**Project Summary – Major Site Plan**

Project: Rail Yard Mixed Use Development (2021-25)  
Property Owner: P&M Realty of Concord, LLC  
Address: Langdon Avenue  
Map/Block/Lot: 7913Z/41, 792Z/70, and 792Z/71

**MEMORANDUM**

**TO:** Beth Fenstermacher, Assistant City Planner  
**FROM:** Gary Lemay P.E., Associate Engineer  
**DATE:** July 12, 2021  
**SUBJECT:** Major Site Plan Review, The Rail Yard, Langdon Ave;  
Map 792Z, Lot 71; (2021-024)

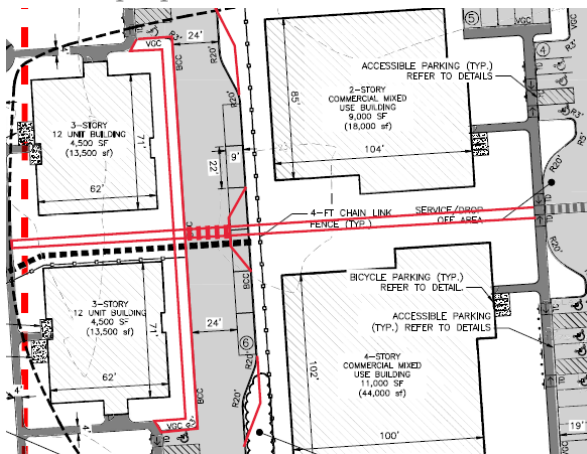
- Please revise the drawings to reflect that all sidewalks are 5 feet wide, exclusive of curbing, per Site Plan regulation 21.05. Some of the proposed sidewalks are currently only 4 feet wide. Where integrated concrete curbing is used, we typically assume a 6" curbing width, meaning the total width should be 5.5 feet. **Comment is addressed; Engineering understands that the proposed internal pedestrian paths will be 4-foot-wide trails and therefore not subject to Site Plan regulation 21.05 in this instance; the path shall still meet ADA standards as applicable.**
- The City would prefer to see a 5-foot-wide striped bike lane on each side of Langdon Avenue instead of a 4-foot-wide bike lane. Lanes should generally be striped as 11- or 12-foot wide.

Please confirm that the existing passage and access easements for Langdon Avenue provide the developer the ability to stripe and maintain markings along the full length of Langdon Avenue. **Comment addressed, but proposed revisions are not to Engineering's satisfaction as the Applicant notes that a bike lane and striping will not be added on the northern side of Langdon Avenue.**
